**APPLICATION FOR CERTIFICATION 07-AFC-7  
SUPPLEMENT A**

**KRCD COMMUNITY  
POWER PLANT**

Re: Supplemental Information in Response to CEC Data Adequacy Request for the Kings River Conservation District Community Power Plant Application for Certification (07-AFC-07)

**KINGS RIVER CONSERVATION DISTRICT COMMUNITY POWER PLANT  
APPLICATION FOR CERTIFICATION (07-AFC-7)  
SUPPLEMENT A**

**KRCDD COMMUNITY POWER PLANT**  
*Energy for our Future*

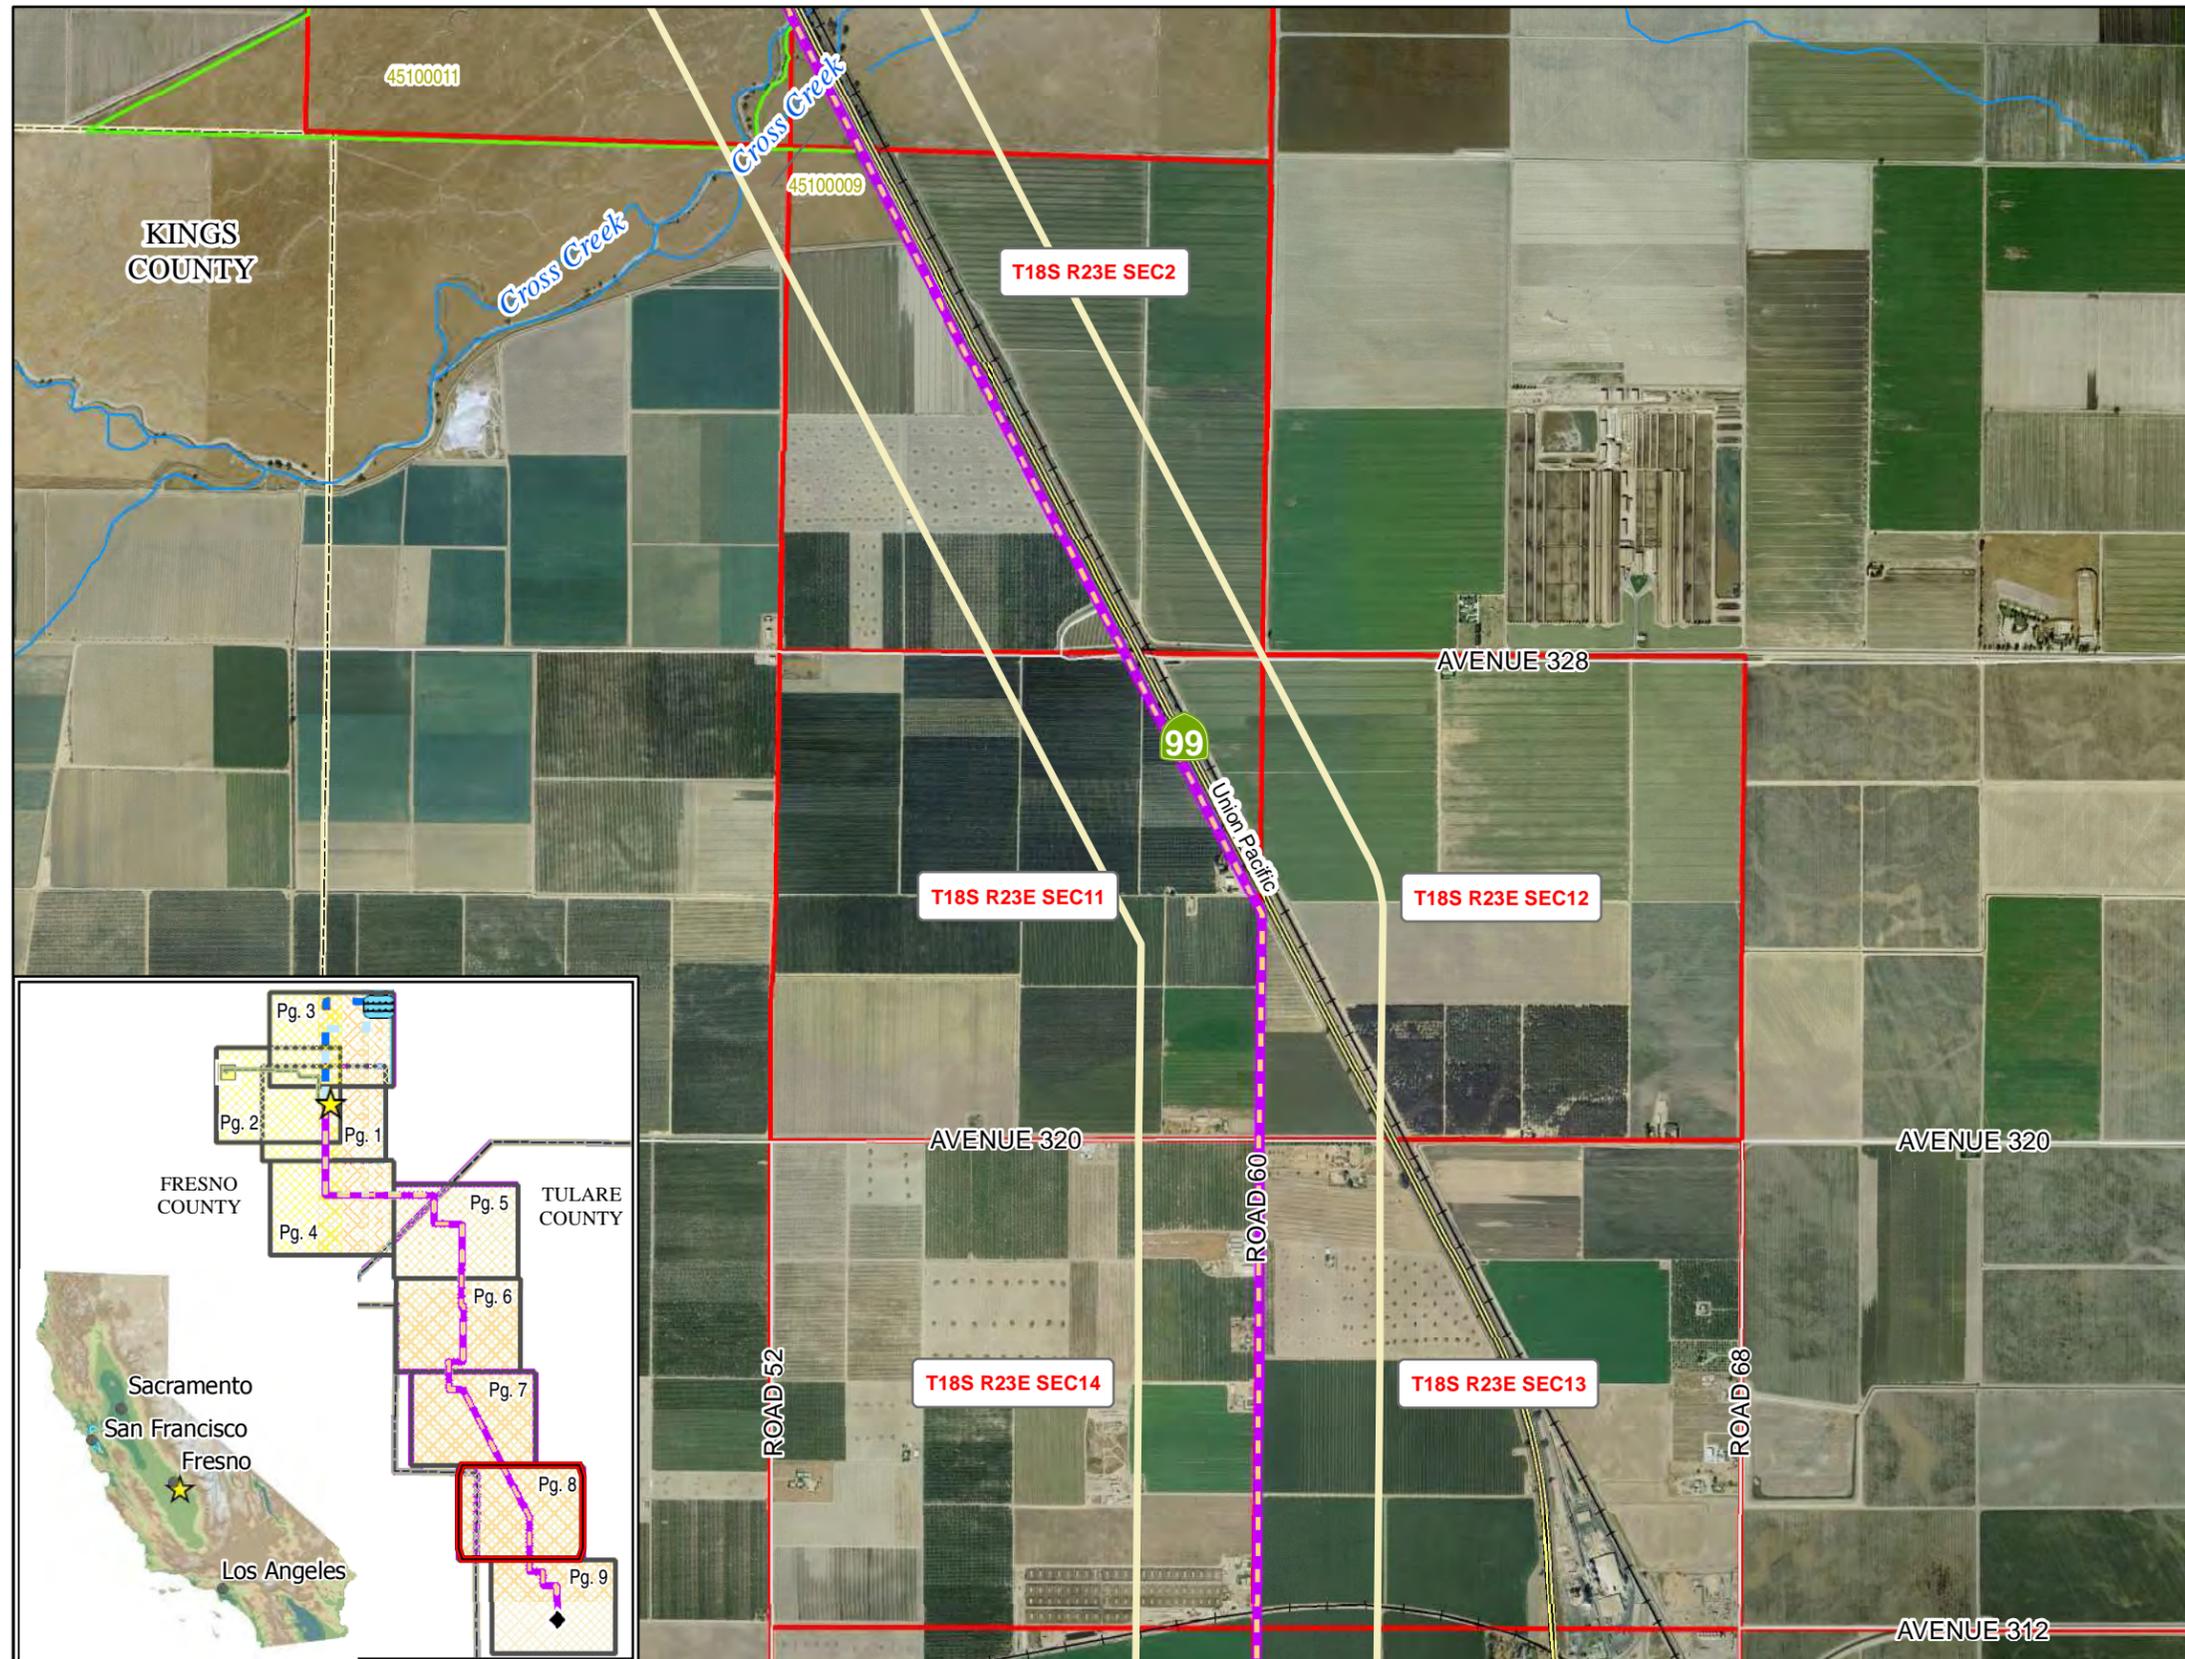
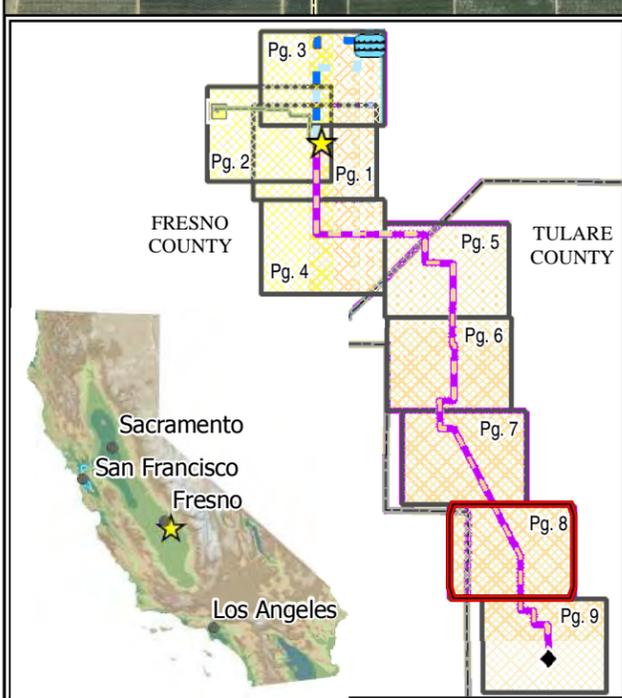
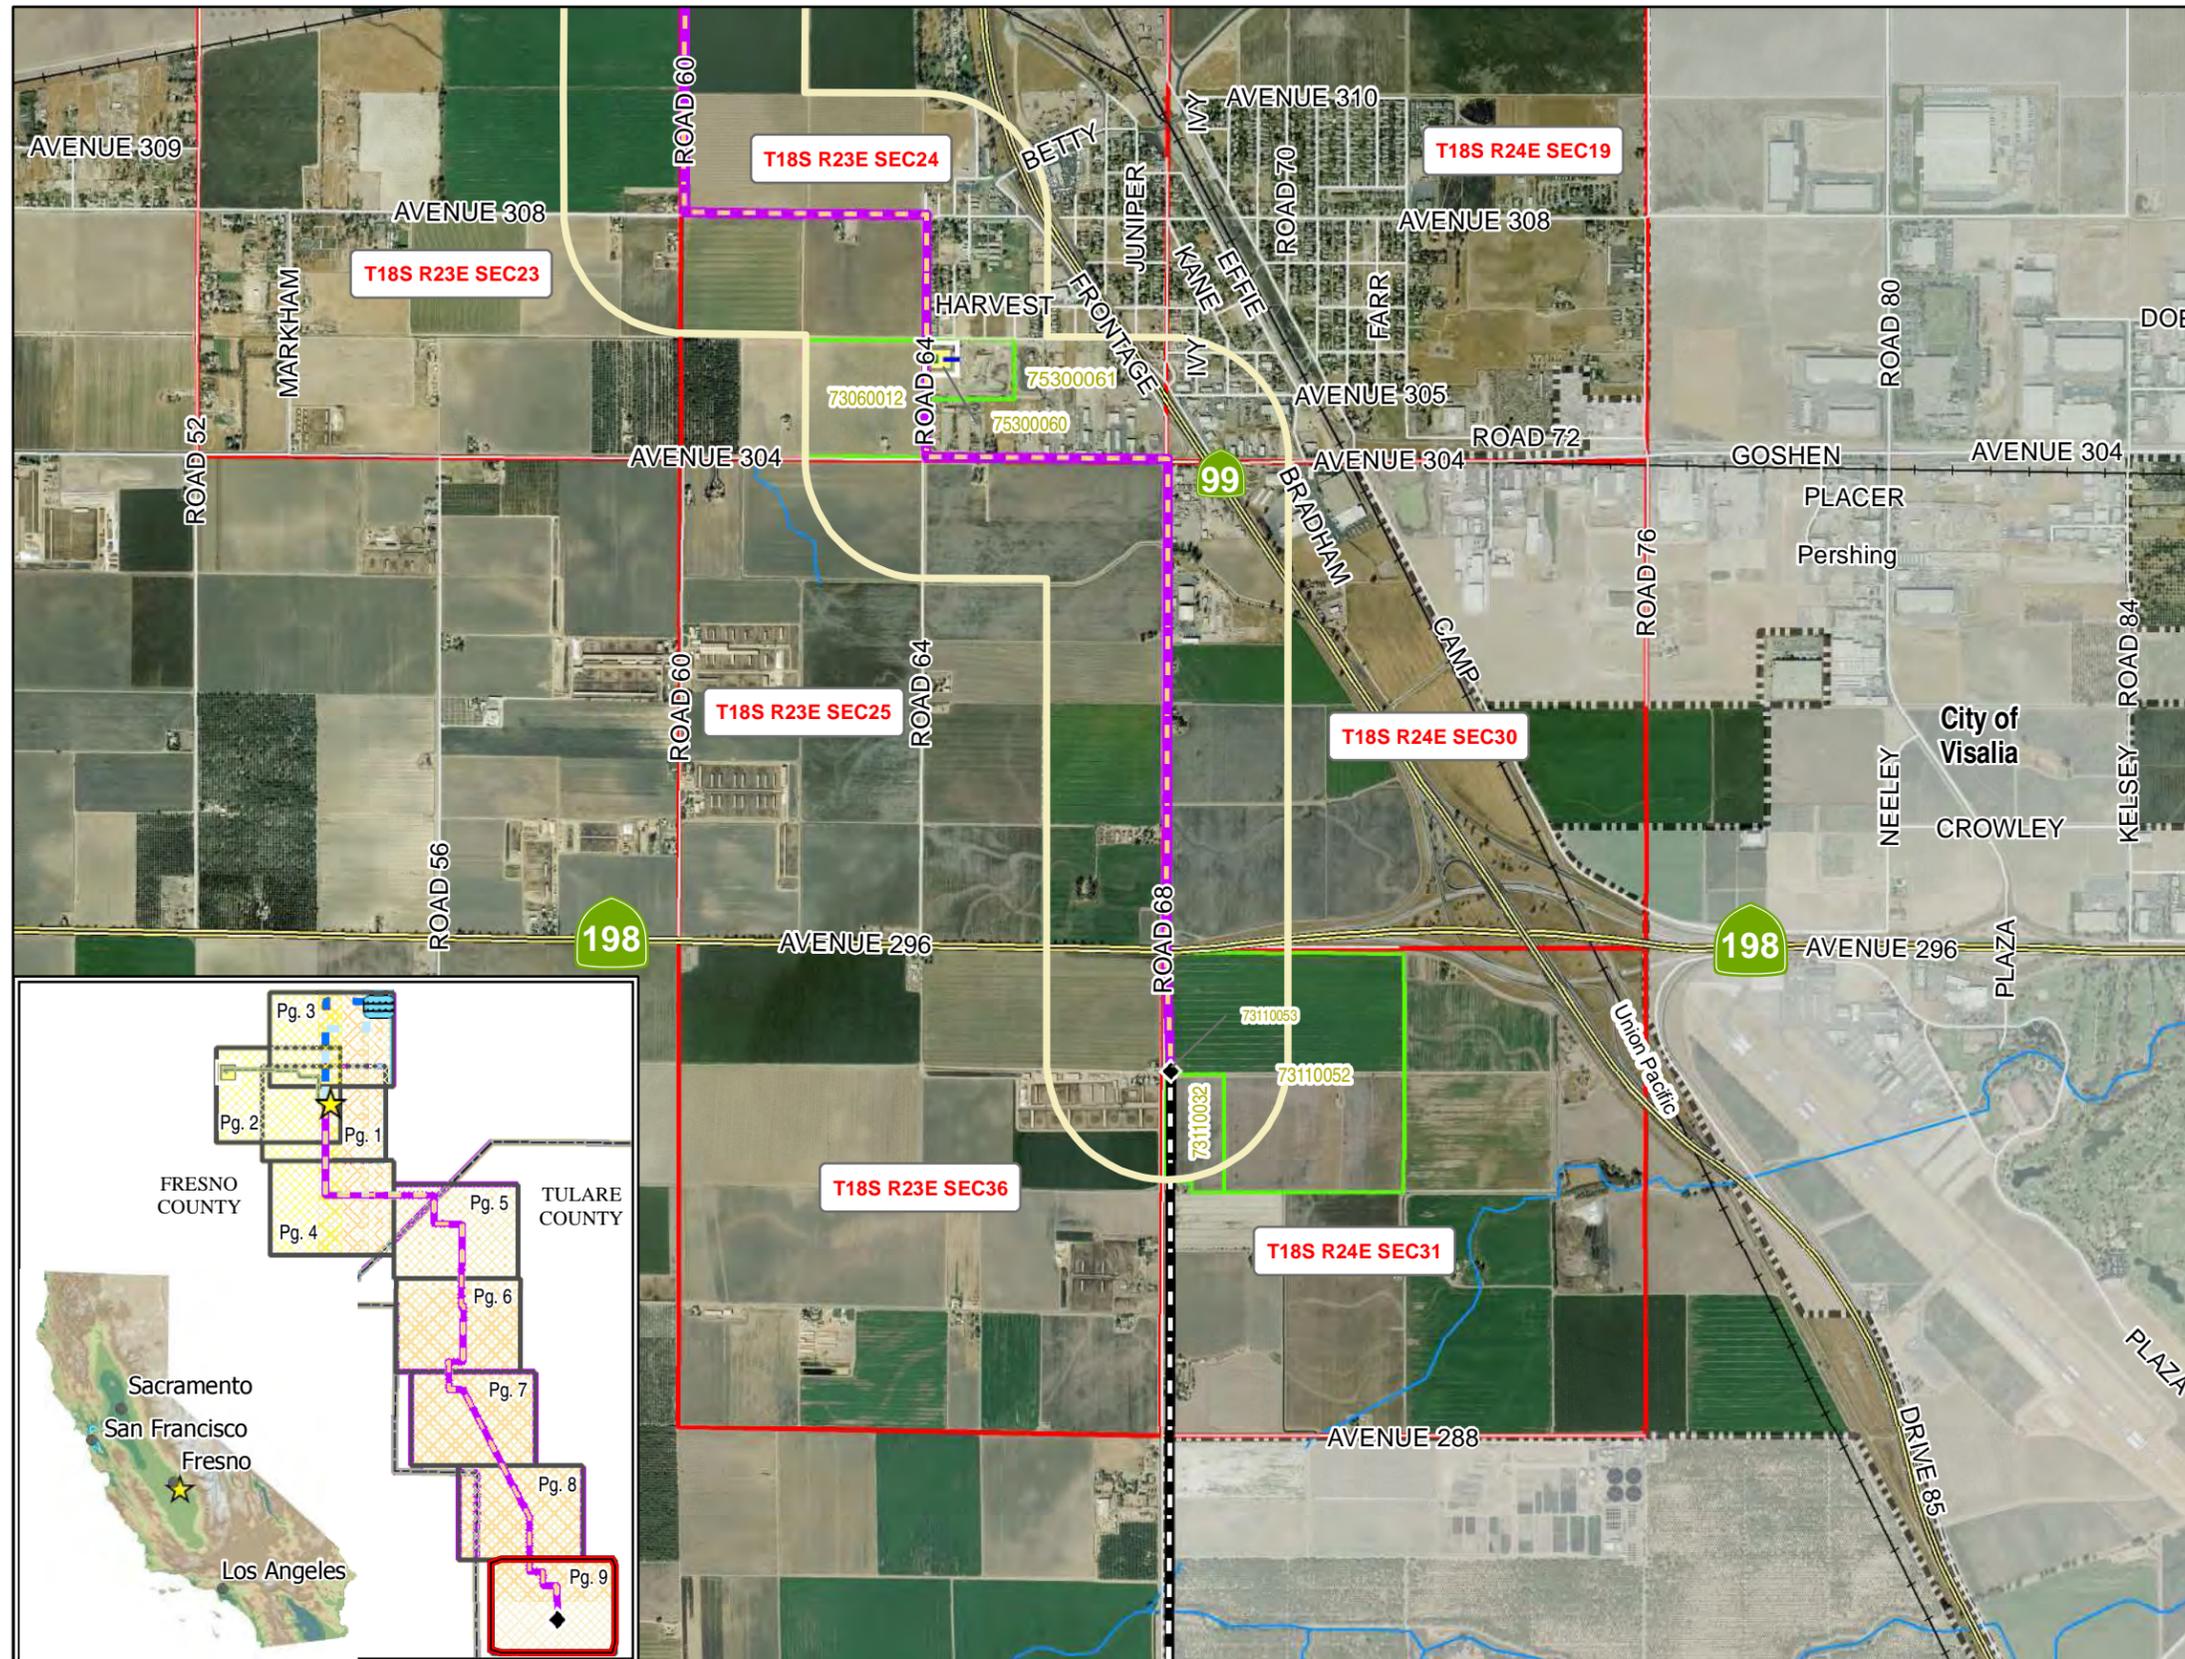
Provide the section, township, range, county, and county assessor's parcel number for the proposed water, gas, or transmission interconnection routes.

Included as Attachment PO-2, are revised Figure 1-3 - KRCD CPP Project Area and revised Figure 2-7 - KRCD CPP Site and Land Description. The revised figures include applicable section, township, and range information as well as the county assessor's parcel numbers for areas where the KRCD CPP project area crosses private property. The attached revised Figures 1-3 and 2-7 should replace Figures 1-3 and 2-7 in KRCD CPP AFC Volume 3.
